UNITED STATES
DEPARTMENT OF THE INTERIOR
BUREAU OF LAND MANAGEMENTCarlsbad Field Office
OCD HobbsFORM APPROVED
OMB NO. 1004-0137
Expires: January 31, 2018**SUNDRY NOTICES AND REPORTS ON WELLS**
Do not use this form for proposals to drill or to re-enter an abandoned well. Use form 3160-3 (APD) for such proposals.5. Lease Serial No.
NMLC032096B

8. Well Name and No.
EAST BLINEBRY DRINKARD UNIT 242. Name of Operator
APACHE CORPORATIONContact: REESA FISHER
E-Mail: Reesa.Fisher@apachecorp.com

Apache is requesting permission to convert this well to injection, per the attached procedure and WBD's.

**Apache Corporation
East Blinberry Drinkard Unit 24
API 3002506530
May 24, 2018**

Proposed procedure to convert this well to injection into the Blinebry Formation

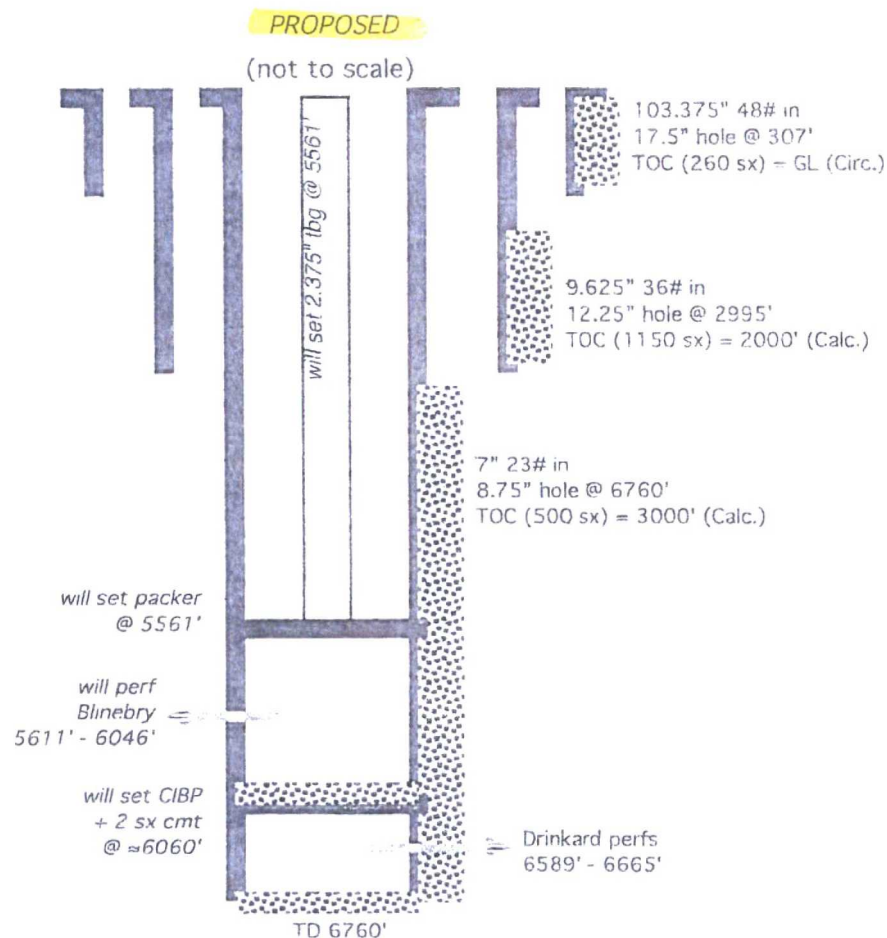
3. TIH with CIBP and work string. Set CIBP at ~6,060' and cap with ~~2 sacks of~~ ^{35' of} Class "C" cement. *or 25 sacks*
4. TOH with work string. PU and TIH with treating packer and work string. Set treating packer ~50' above existing Blinebry perforation. Load the casing with produced water. Pressure test the casing to 500 psig for 30 minutes. Release the pressure and packer. TOH with the work string and treating packer.

Well Name: EBDU 24

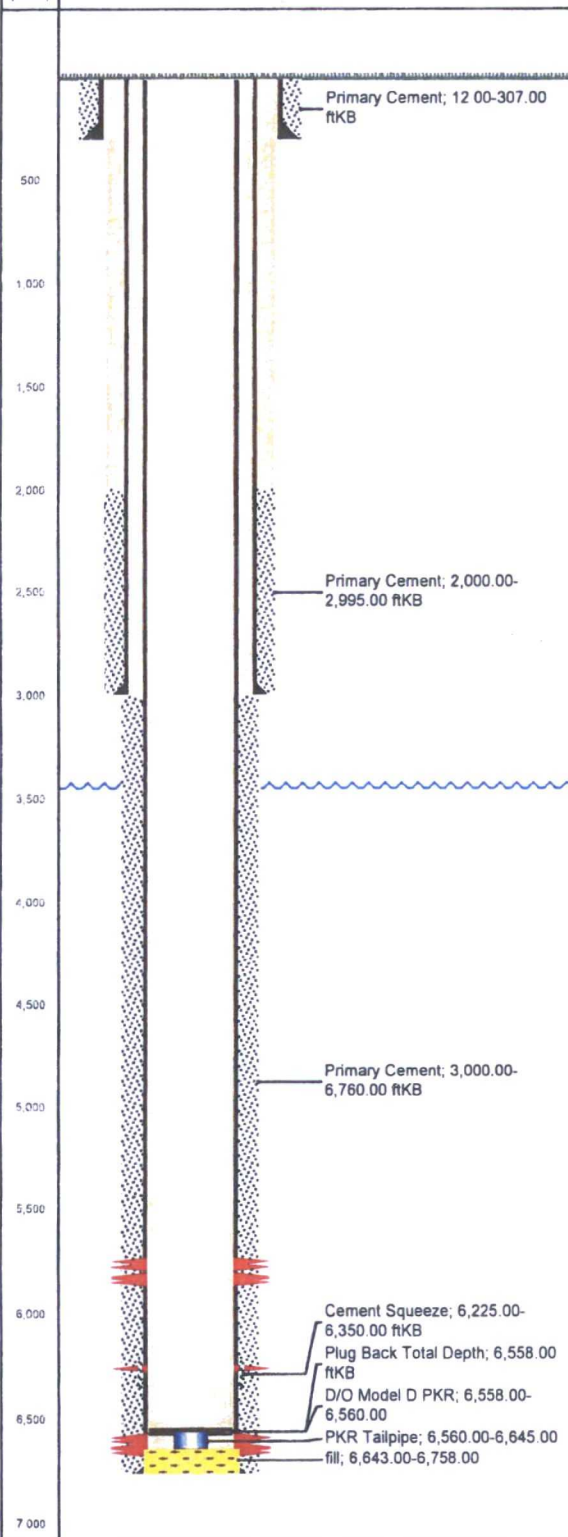
Remedial work needs to be done either on 9 5/8" or 7" casing in order to bring cement to surface or at least tie-back 200' into previous casing..
